AUBREY DAVIS PARK TRAIL SAFETY IMPROVEMENTS

PARKS & RECREATION COMMISSION MEETING
APRIL 7, 2022

Conceptual Alternatives / W. Mercer Way Trail Crossing

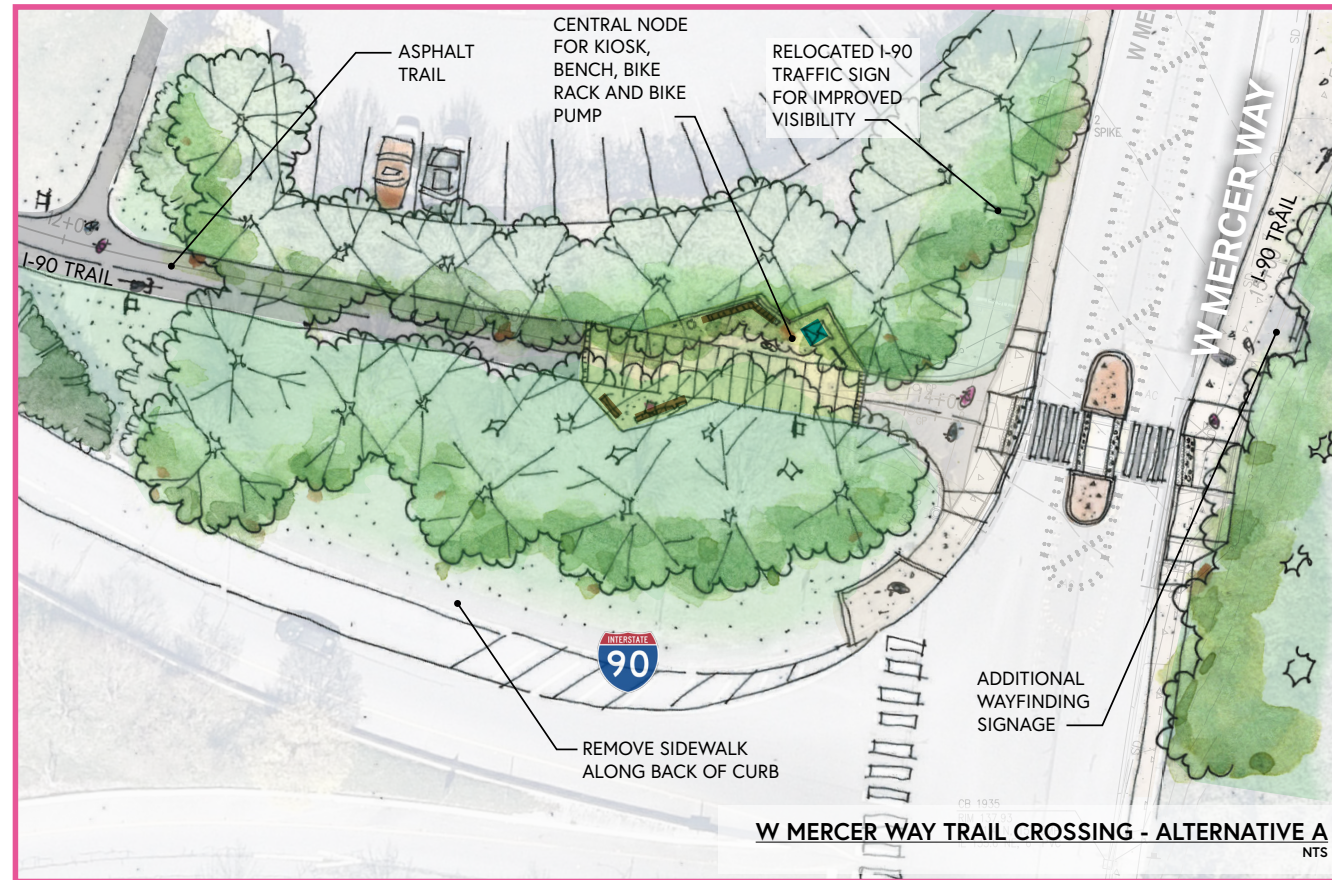
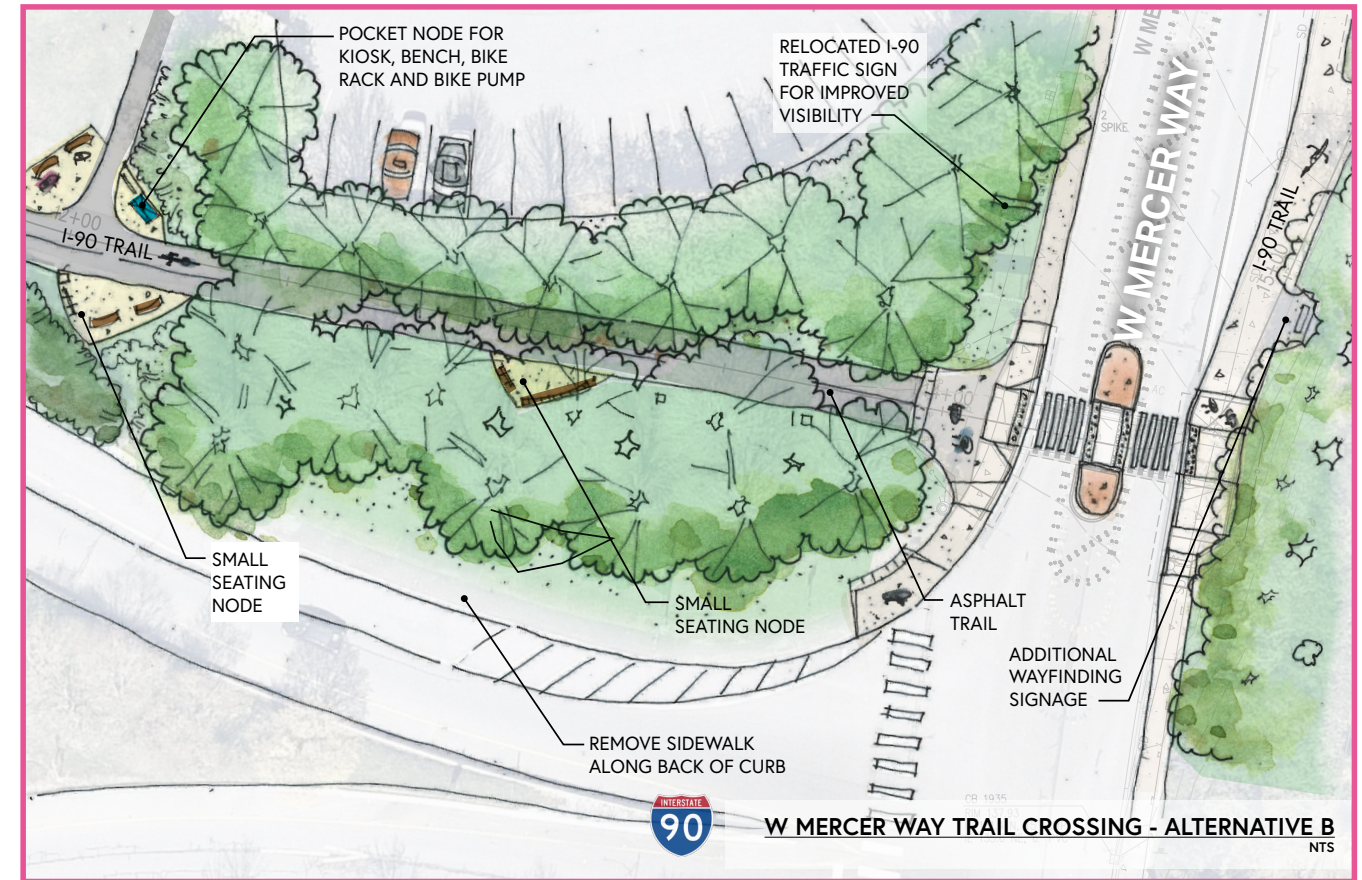
"The nodes are intended to give riders a resting area and access to bike amenities (pump/bike rack). At present, some **cyclists gather in that area** to regroup or meet up with other riders before circling the island and the nodes would enhance that option." (LT)

"Remove sidewalk along back of curb. That sidewalk is not used by cyclists (in my experience) and I don't believe cyclists would miss it. Pedestrians may use it when walking down to the bottom of the hill." (LT)

"I'm ambivalent about the 'nodes,' constructing a kiosk is a good idea. If we had a kiosk there (or near the restrooms as is also an option) the city could post cycling maps and the Island's "Rules of the Road" document." (LT)

Having a node closer to the streetside would allow for **better access for maintenance** and can provide **more visibility** from the road (have more eyes on it). (City Staff)

"I also don't get the kiosk. Three nodes and a kiosk start to look like park clutter to me." (LT)

"I like Alternative A—one [central] node is **less busy** and the location I think works **better for wayfinding** and encouraging the use of the alternative route on West Mercer Way that goes around the park." (Open House)

"Seems best for **how** I see **people use that area**." (Open House)

Why can't we do both [alternatives] A and B? (Open House)

Design Team responded that *the number of alternatives chosen are **dependent on budget**. The project team is looking for feedback on desired conceptual preferences which will help inform how many improvements can be made.*

Conceptual Alternatives / Trail Connection under 72nd Ave SE Overpass

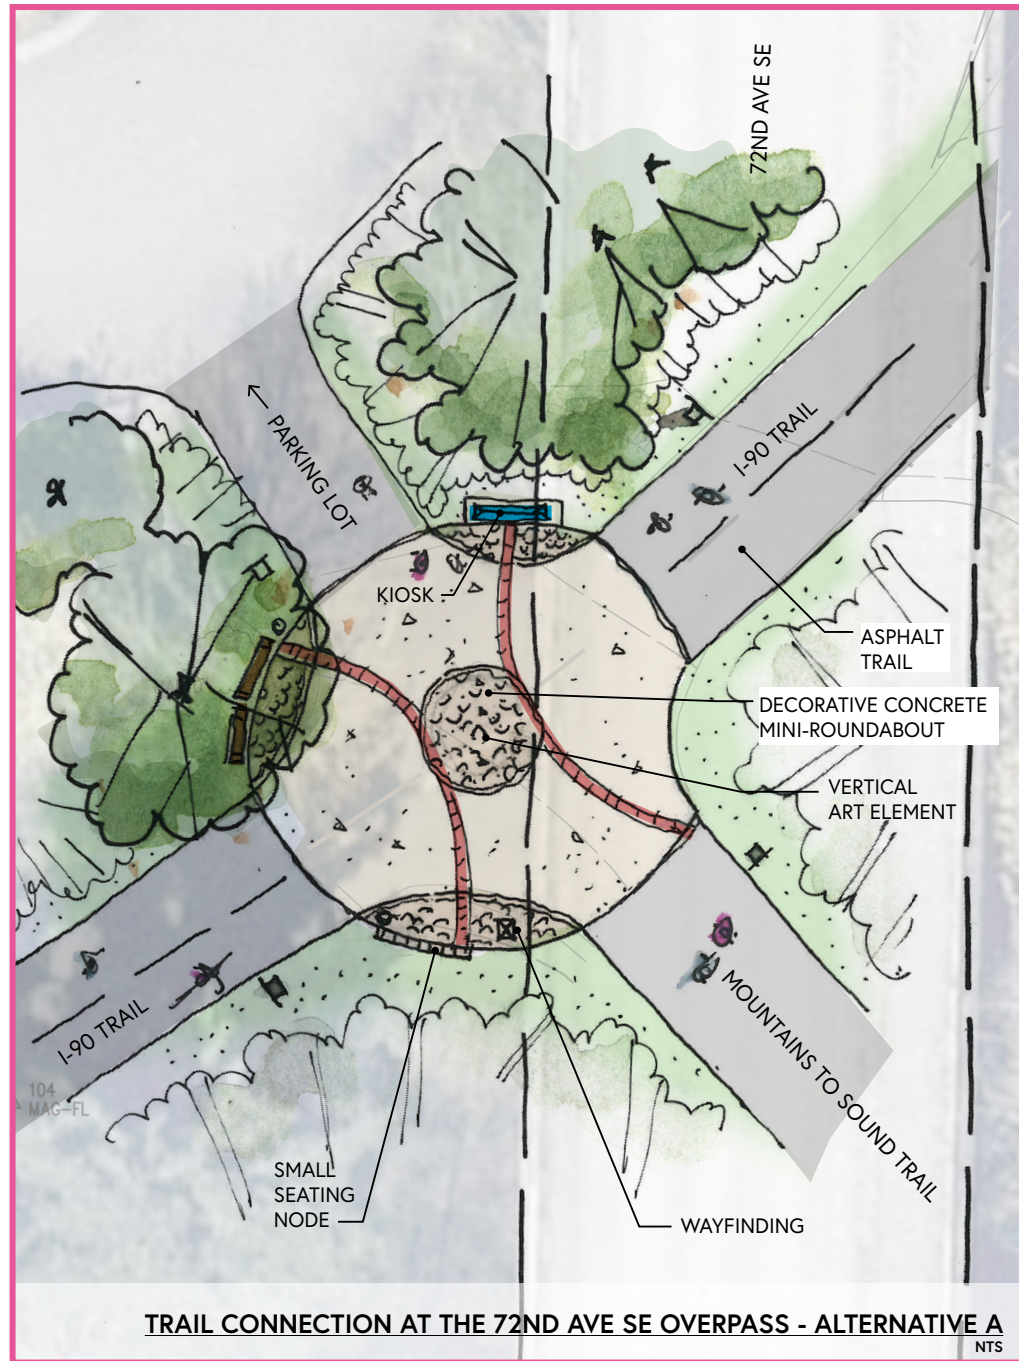
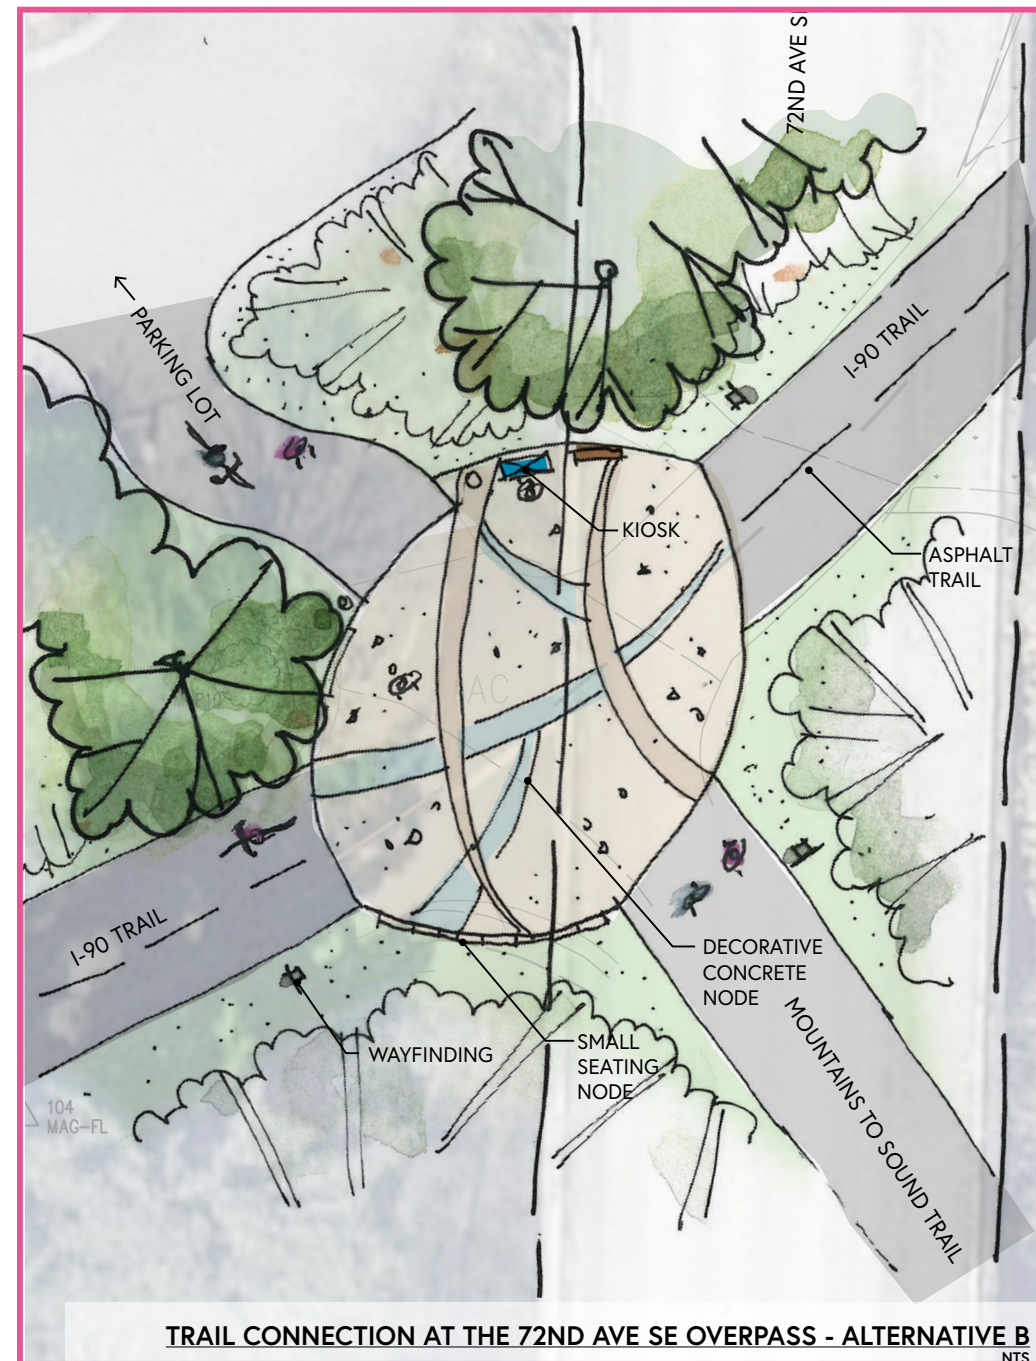
"I do think some **traffic calming** measure will be necessary at the backstop which is the "Y" for both trails going to the town center. If bicycles are slowed at this juncture, I don't think they can create more speed by the bathroom." (LT)

"Or why would you run the path from the parking lot to the roundabout? This is the one area we want to separate slowing bikes and pedestrians, not mix them... And **eliminate the current path from the parking lot** to where the roundabout will be located, and as noted below route those pedestrians to a marked crossing closer to the bathroom where bike speeds will have slowed." (LT)

*"I like the roundabout. Strollers and dogs tend to wander across the path, and this is the worst sightline area, in my opinion. If installed though, there would have to be some very strong pavement paint to **encourage turning short.**" (Open House)*

*"...We want to **slow bicyclists**...The roundabout has to be designed to allow a bicyclist who did not slow enough earlier to recover..." (LT)*

*"I'm a fan of the roundabout option, even if it's not raised, it could still **signal people to pay attention** to who has the right of way." (City Staff)*

*"...while roundabouts are often used on streets (and cyclists are familiar with them), they are hardly ever used on trails.... **don't know where pedestrians are supposed to be on the roundabout.**" (LT)*

*"This node should **continue to have the striping that separates** the sides of the trail, but otherwise this option is fine." (LT)*

*"I like Alternative B because it realigns the trail from the parking lot and **improves sight lines.** That could be accommodated in Alternate A, couldn't it?" (Open House)*

Conceptual Alternatives / Restroom Facilities & Playfields Node

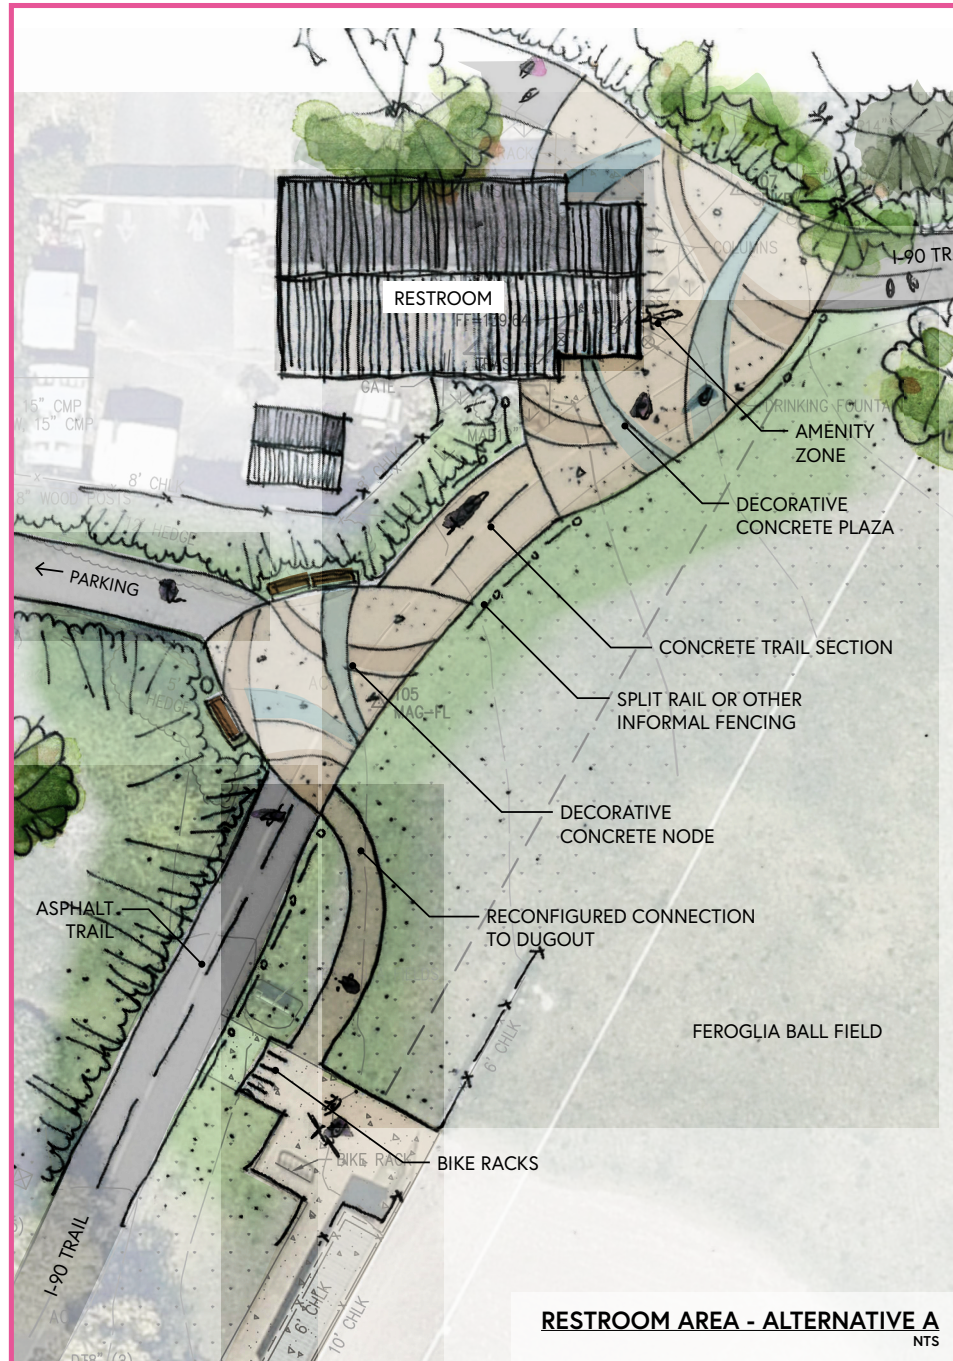
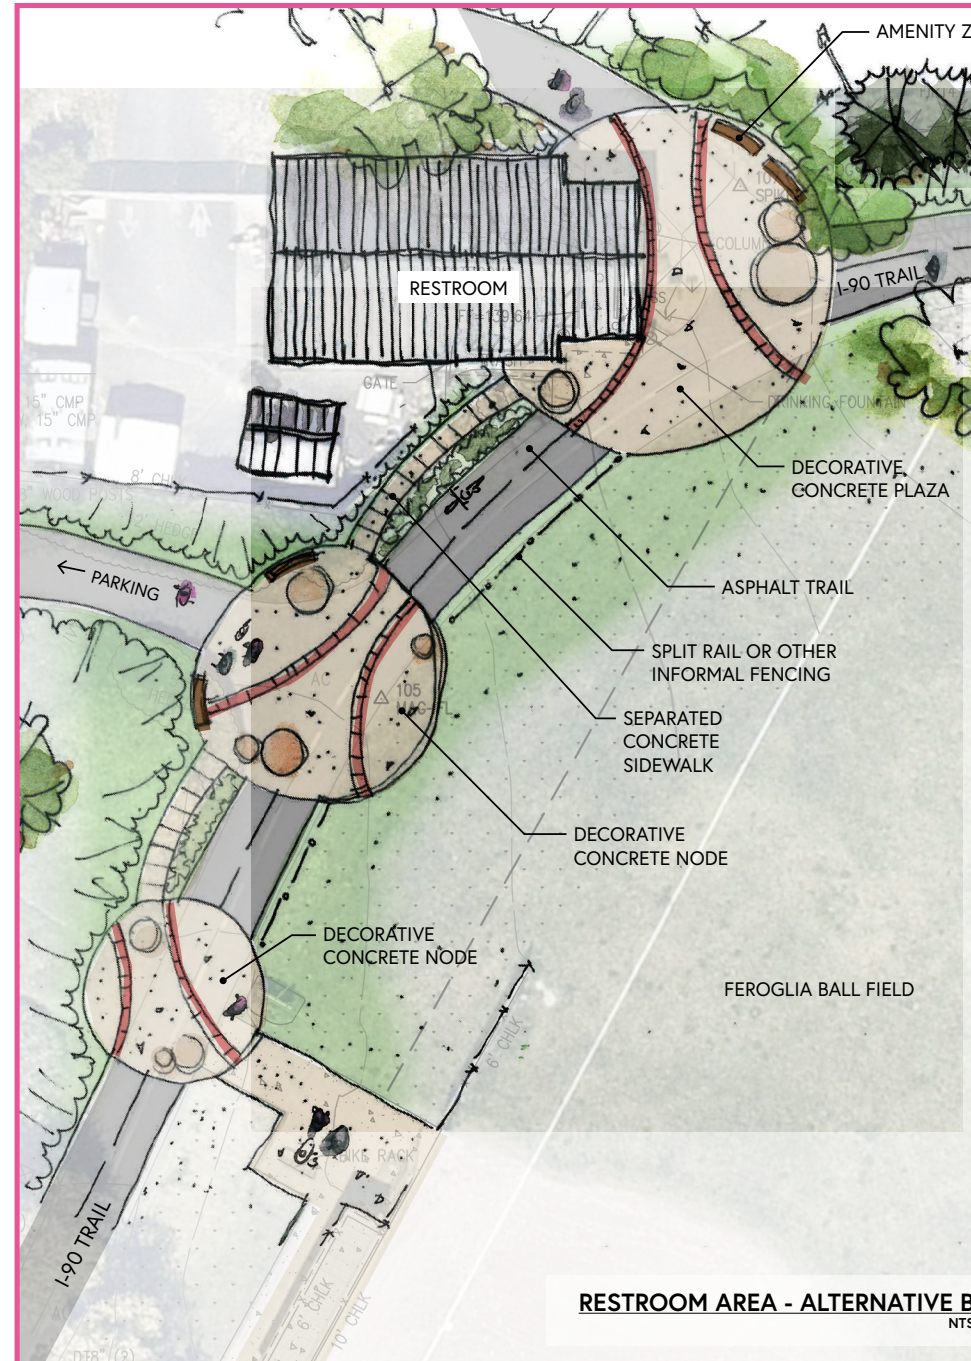
All users could benefit everyone by **being more self-aware** of how their actions affect others." (LT)

"You want [users] to walk along the **grass** part of the field to cross closer to the bathroom in a central marked crossing where bike speeds are low, not near the roundabout." (LT)

"These would **funnel pedestrians (and dogs)** from the parking lot **to a central main crossing** in the trail after the roundabout so bike speeds are slow and this part of the trail crossing is marked." (LT)

"In several places the plan calls for '**informal fencing**' to control where pedestrians can cross the trail. This is an **effective, low tech way**, of giving users of the **trail predictability** as to where pedestrians will cross.... I would additionally **add raised cross walk markings** on the trail in those locations." (LT)

"I don't like the plan to expand the gathering area with **impervious surfaces** that extend into the grass field." (LT)

Alt A is more straightforward and will require **less signage** than Alt B – providing **less park clutter**. There are fewer numbers of mixing zones (compared to Alt B) and **minimized points of conflict**. (Design Team)

Alt A has no separated landscape buffer and will require **less maintenance** than Alt B. (Design Team)

“Why would a pedestrian cross a paved path from the dugout to reach another path when they can just walk on the main path and have legal priority?” (LT)

“If you need to meet the letter of the law, make a 12’ trail through the plaza and then give it a 6’ apron. Or call it a plaza. Trail, asphalt. Plaza, concrete. Two different things...**the separate trail just means you’ll have pedestrians on both trails.**” (LT)

“It **REQUIRES** anyone on the field wanting to use the bathroom to cross the trail to get to the walking trail at all different points, exactly what you don’t want to do.” (LT)

People who preferred option B liked it because it provided more space and ultimately the public had a **perceived notion that the separated pedestrian and bike paths provide more space**. (Design Team)

“In constrained areas **where widening a single trail is not practical**, the multi-use pathway separates into **two trails** so walkers and bikes can still be separated.” (LT)
